Final Environmental Statement

related to the operation of
**Susquehanna Steam Electric Station,
Units 1 and 2**

Docket Nos. 50-387 and 50-388

**U.S. Nuclear Regulatory
Commission**
Office of Nuclear Reactor Regulation

Fig. A.2.5. Floodplain of Pond Hill Creek

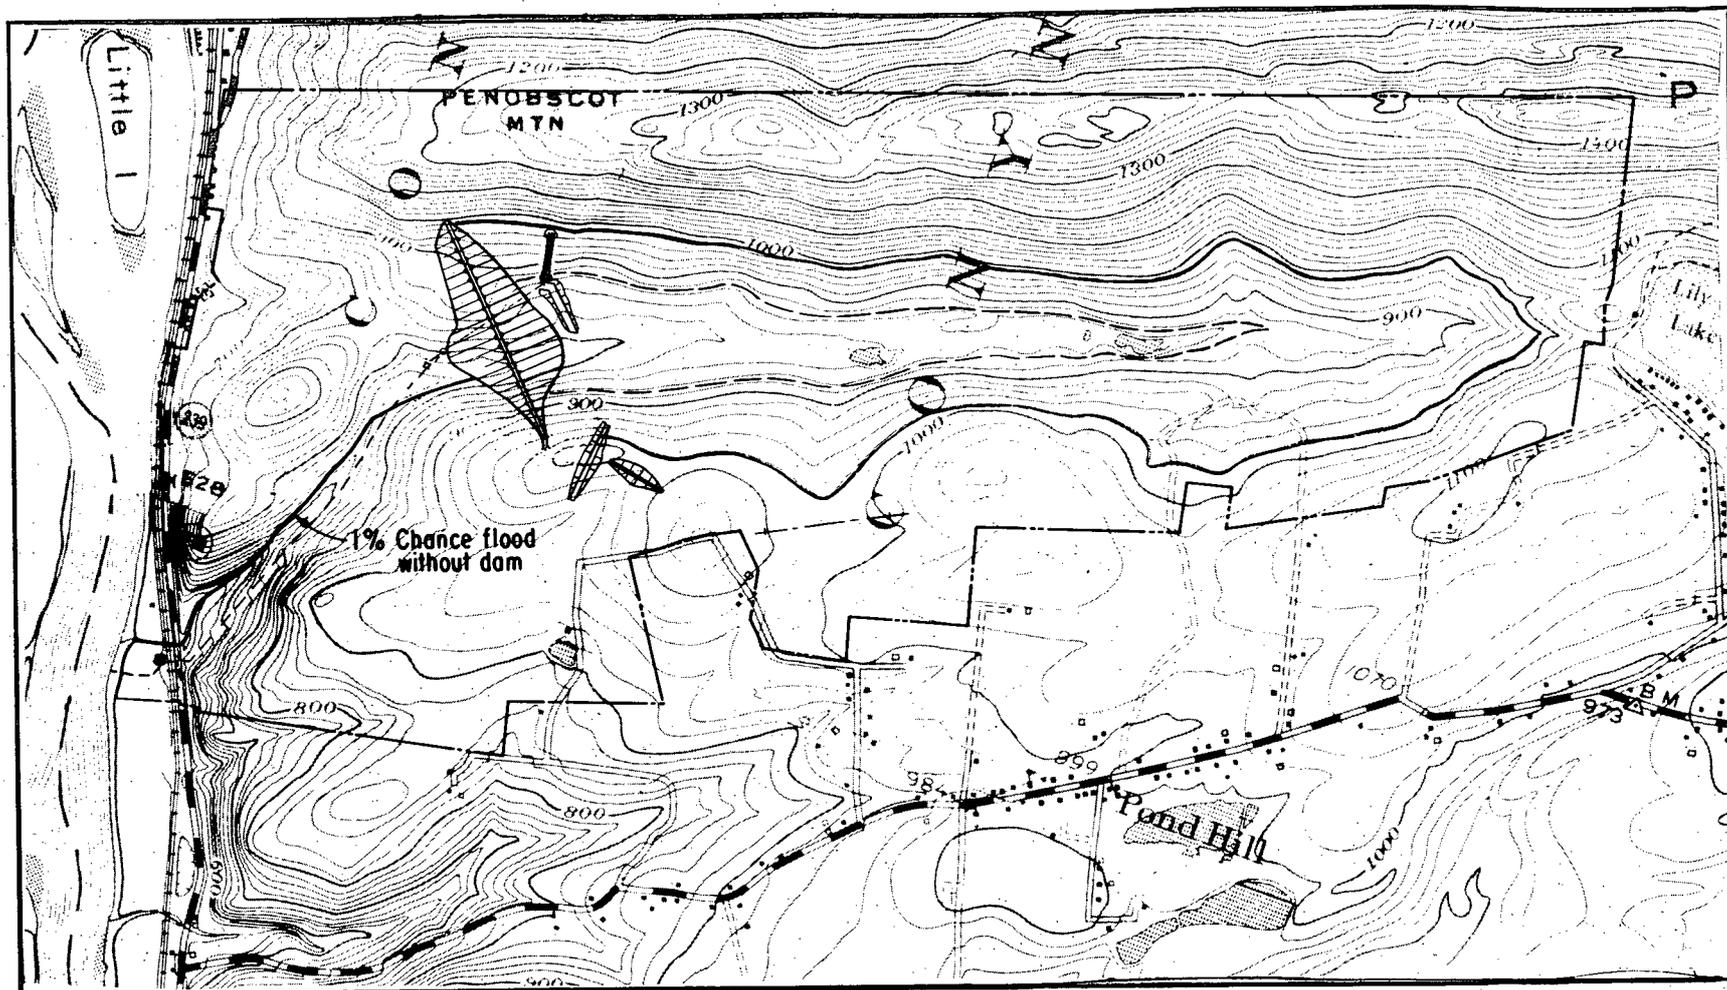
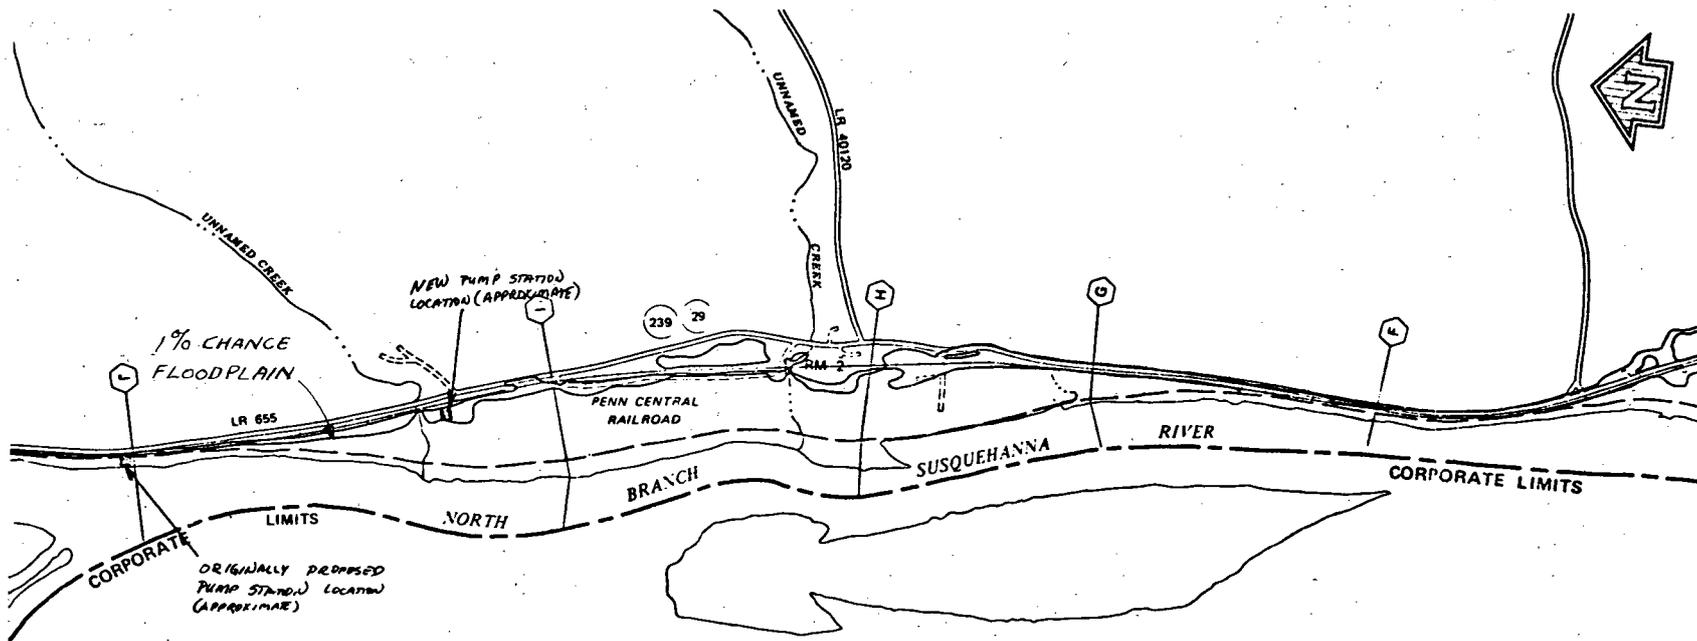
It is also stated that the pumping station lies outside the 100-year flood plain. We are unable to verify that statement because of the level of detail used in Figure 2.5. However, the pumping station clearly lies outside of the floodway.

The figures showing the floodplains of the Susquehanna River and Pond Hill Creek have been revised. See Figures A.2.5 and A.2.6.

Fig. A.4.1. Inlet-Outlet Structure.

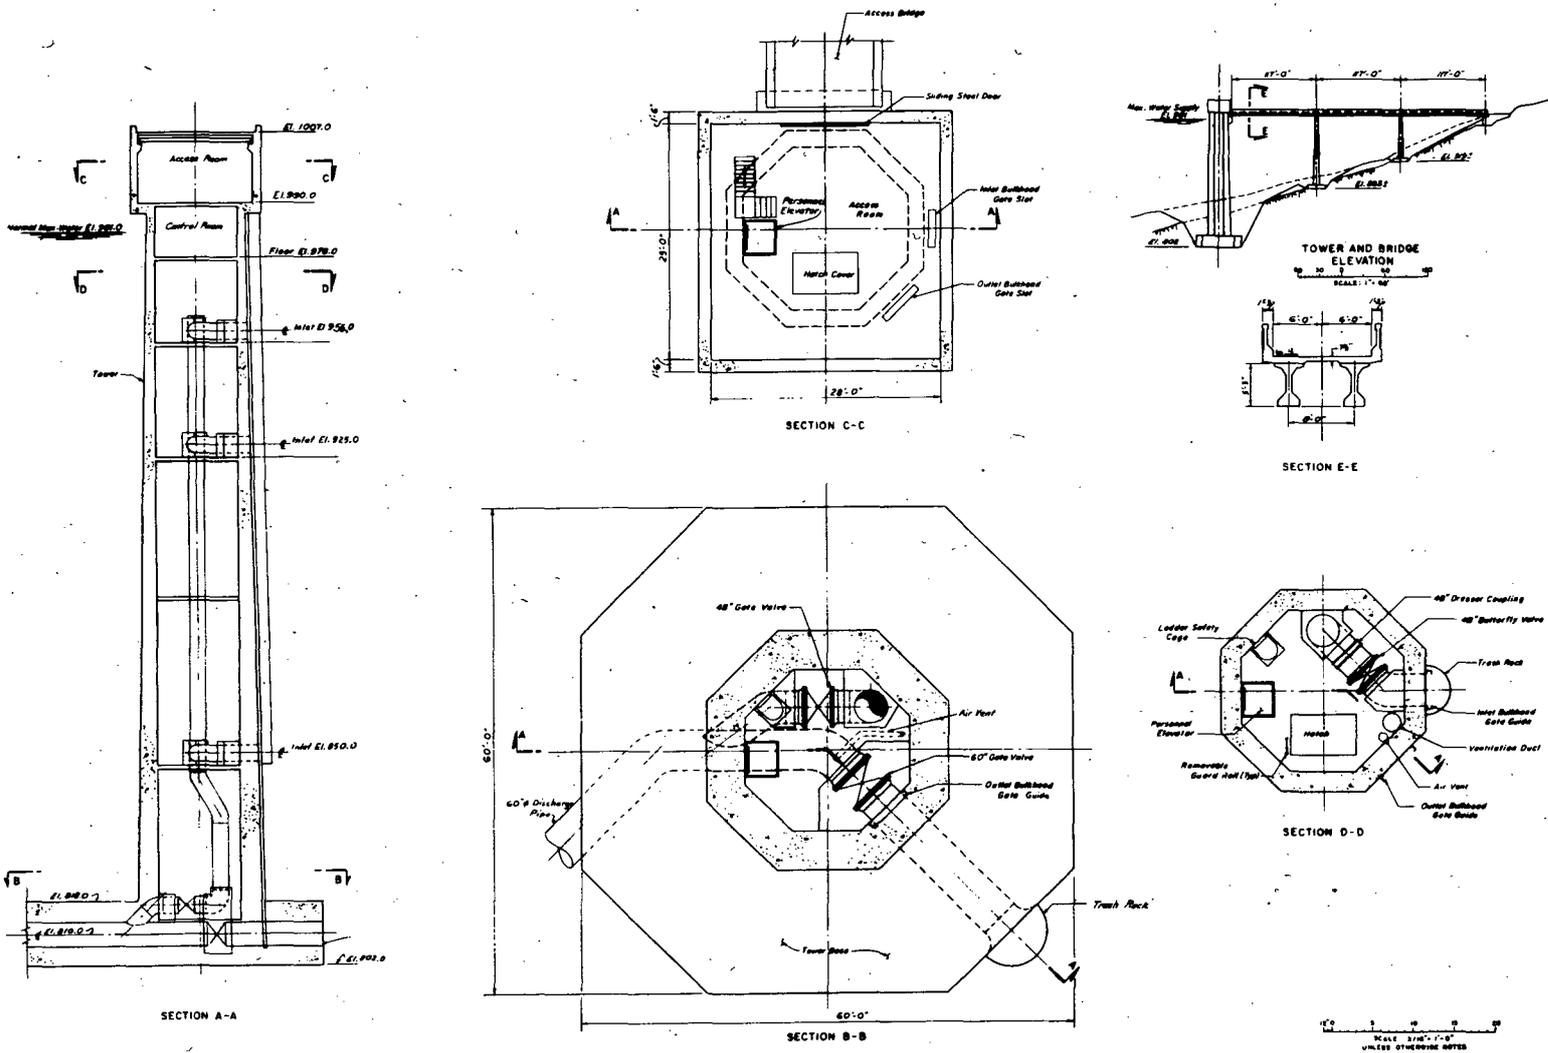
- 4) Section 3.1.3: The project concept for the inlet-outlet structure has recently been revised from the inclined structure previously proposed to a conventional multi-port vertical tower. Three outlet ports will be provided, at Elev. 956, 925, 850 MSL. The attached Plate 6 shows the revised inlet-outlet structure concept.

The text and Figure A.4.1 have been revised to reflect applicable comments.

This structure has been redesigned since the DES was issued in March 1980 (letter from M.N.W. Curtis, PP&L to Mr. B.J. Youngblood, NRC, 29 May 1980: this letter is on page B-47 of Appendix B). The new structure is shown schematically in Figure A.4.1; its location is given in Figure A.2.3). The new design calls for a vertical structure inside the reservoir, with exit ports 7.6, 17.0 and 39.9 m below the normal water surface.
